H11465

DESCRIPTIVE REPORT

General Locality Southwestern Alaskan Peninsula

Sublocality 20 NM SE of Castle Cape

Figure 1 H11465 Area Surveyed

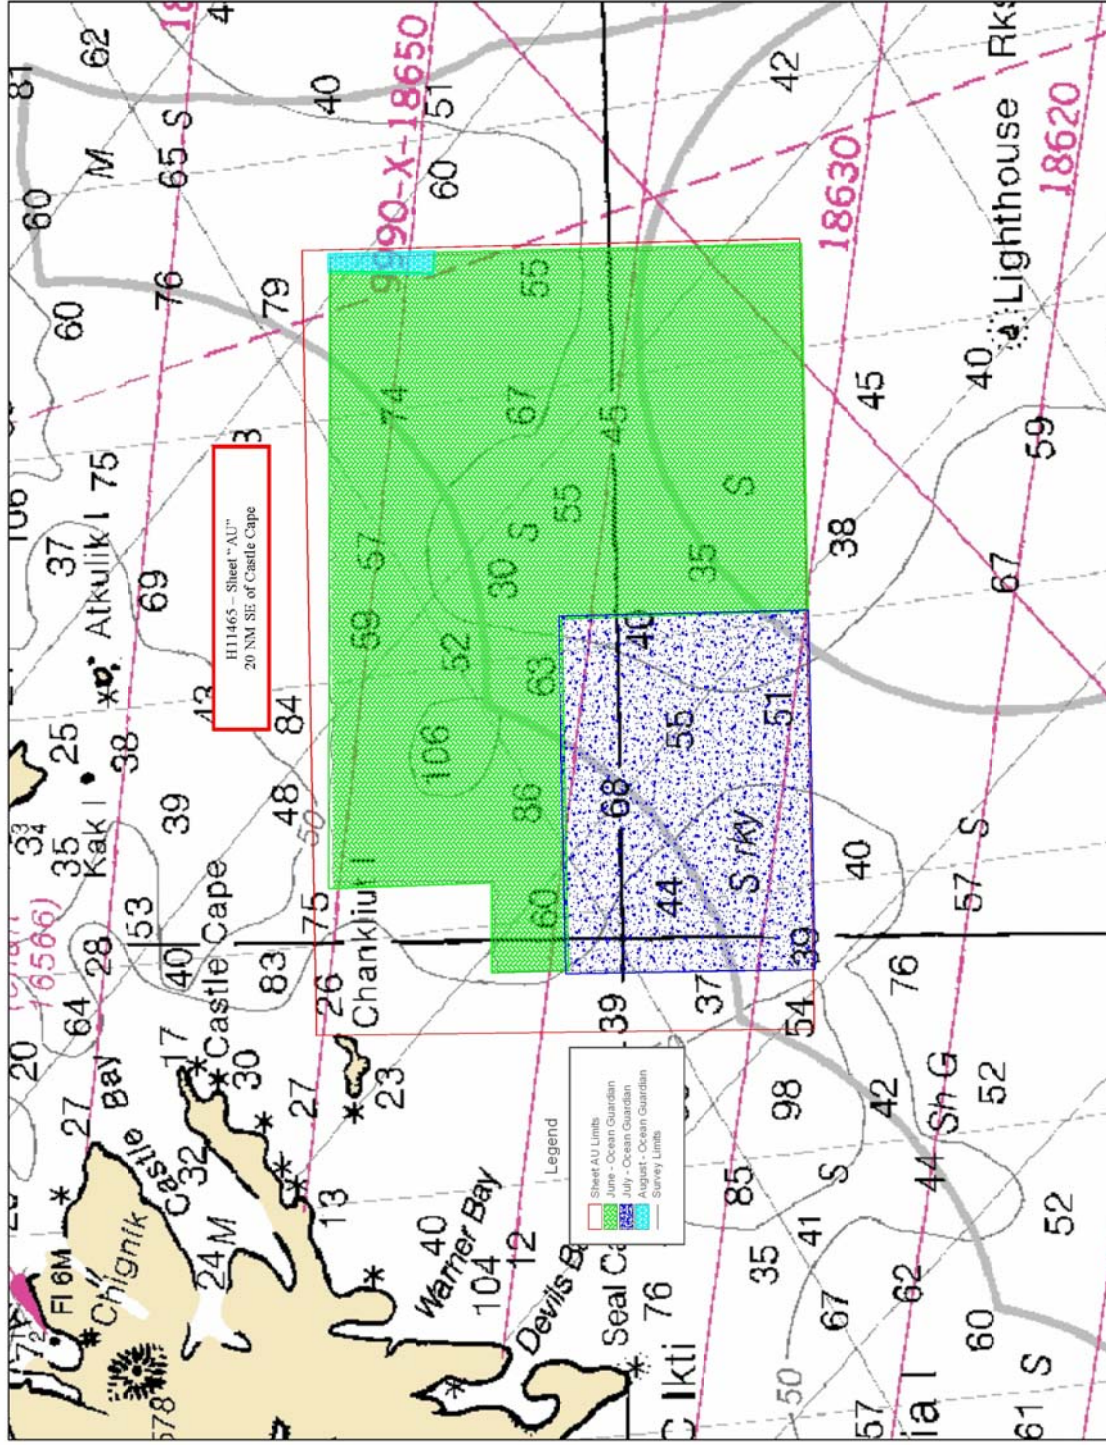
H11465 (Sheet AU) is bound by the coordinates listed below, which encompass the area 20 NM SE of Castle Cape.

Table 1 - H11465 Sheet Limits¹

- ¹ Revise sheet limits to the following:
56/09/50N, 158/02/00W
56/09/50N, 157/19/00W
55/54/00N, 157/19/00W
55/54/00N, 158/02/00W
- ² Filed with the project records.

Figure 2 H11465 Survey Junctions

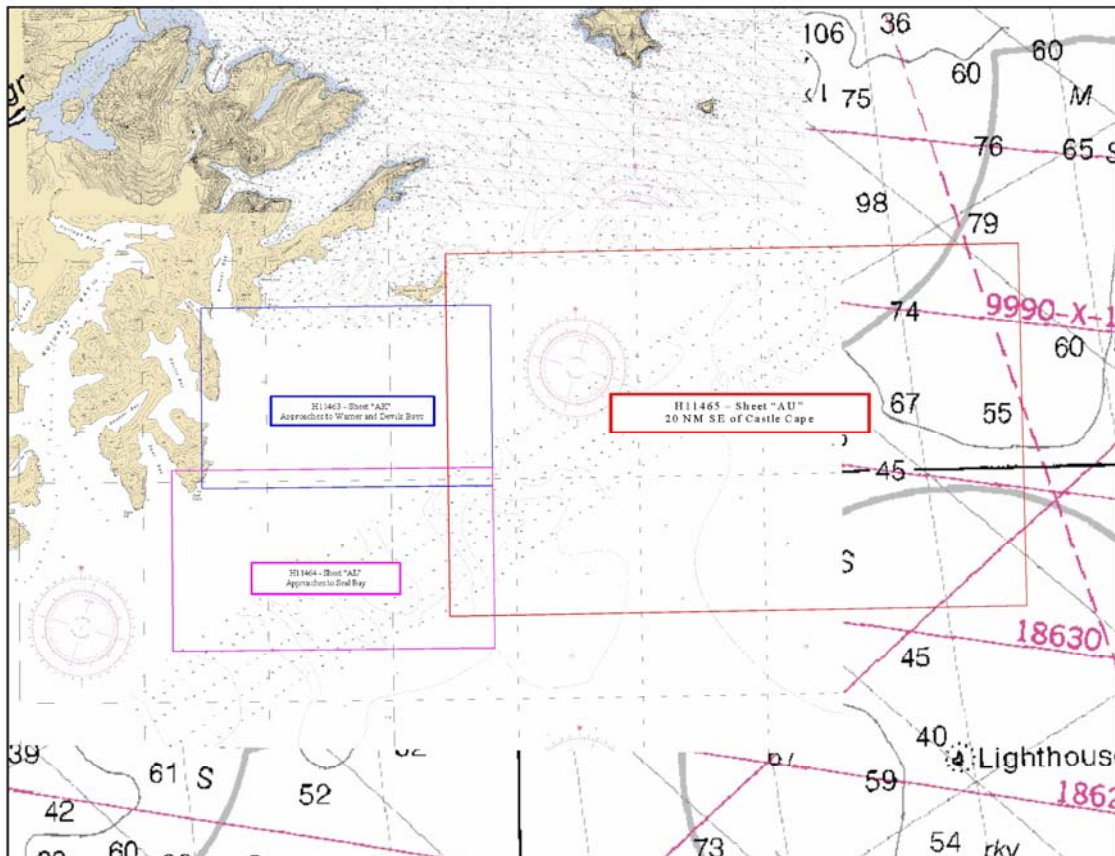
Registry #	Scale	Date	Junction Side
H11463	1:20,000	2005	East ⁶
H11464	1:20,000	2005	East ⁷

The surveys are in agreement along their common borders. The agreement was noted in the field using the 2 and 5 meter DTM's created for coverage verification. The conformity is also apparent in the preliminary smooth sheets.⁸

- ³ Concur.
- ⁴ Concur.
- ⁵ In addition to the junction surveys listed below, H11465 adjoins H11021 (2002, 1:40,000) to the north and H11465 adjoins H11062 (2001, 1:40,000) to the east. The Hdrawing has been compiled in consideration for all junctional data sets within the common area.

- ⁶ Strike "~~East~~" and insert West.
- ⁷ Strike "~~East~~" and insert West.
- ⁸ Concur with the hydrographer's comments above.
- ⁹ Filed with the project records.

Figure 4 Comparison of Contours

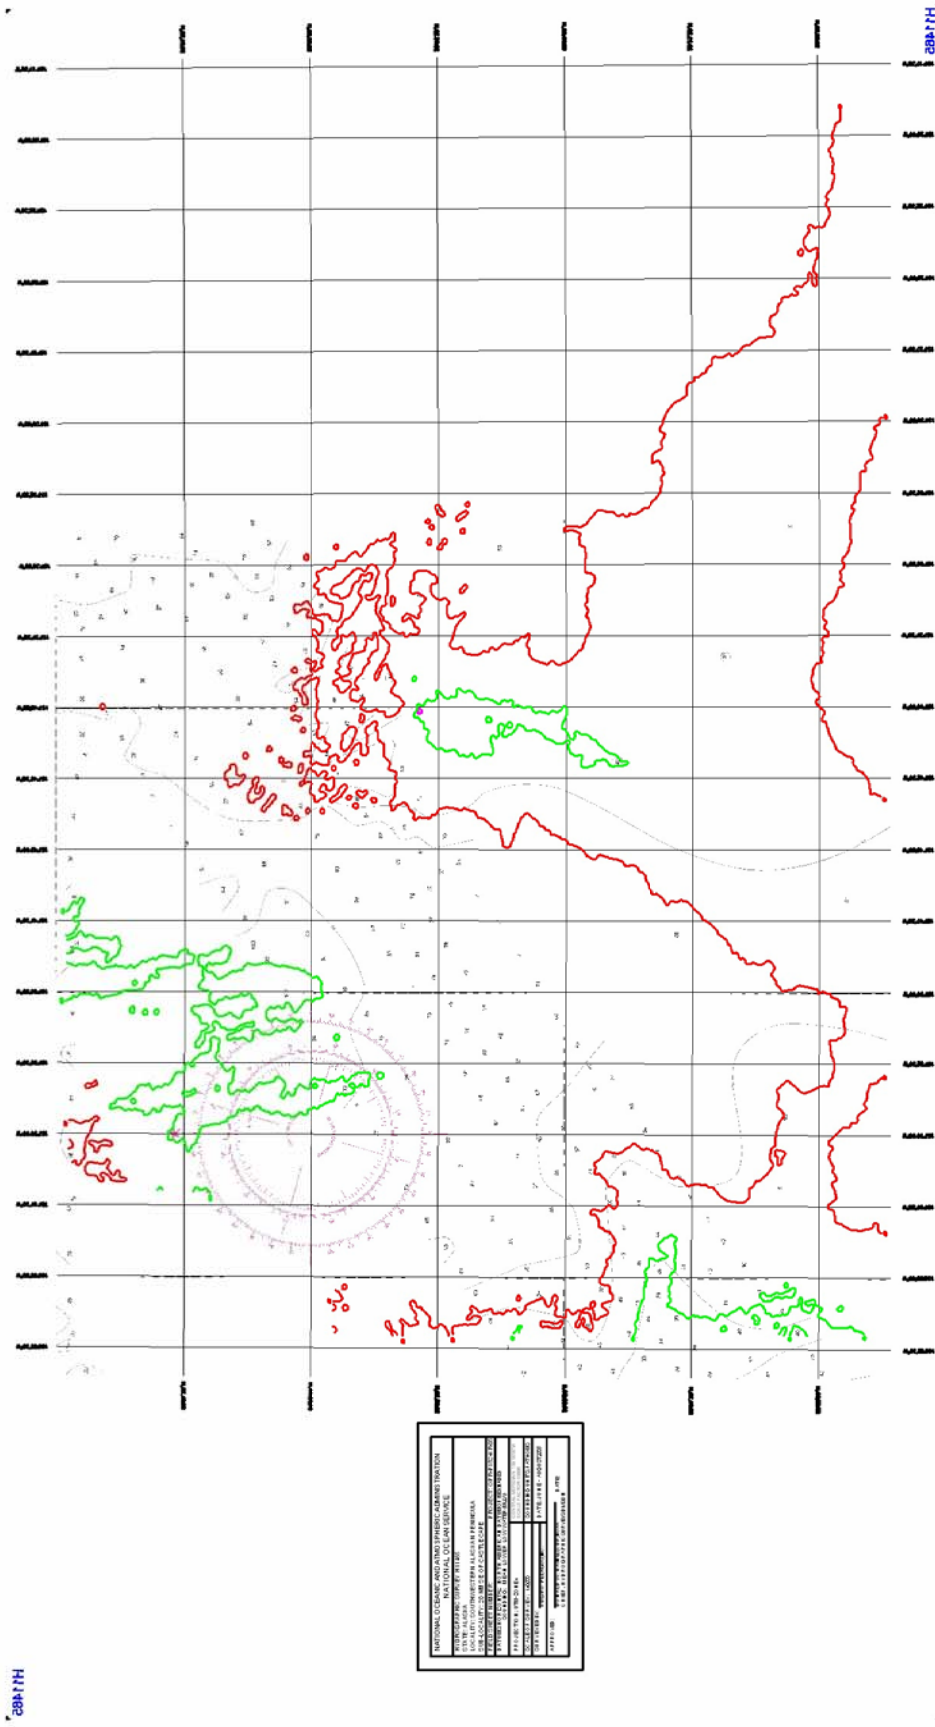
Figure 4 illustrates that the contours from H11465 take on the same general shape, but certain areas do deviate from the existing contours on chart 16561. It should also be noted that since the contours on H11465 are derived from a very dense shoal biased multibeam data set and the existing charts are based on sparse single beam or lead line data sets, that deviations from the existing chart or charts should be expected.¹⁶

- ¹⁶ Concur with the hydrographer's comments above. Chart contours as shown on the Hdrawing. Survey H11465 is adequate to supersede charted soundings and features within the common area.
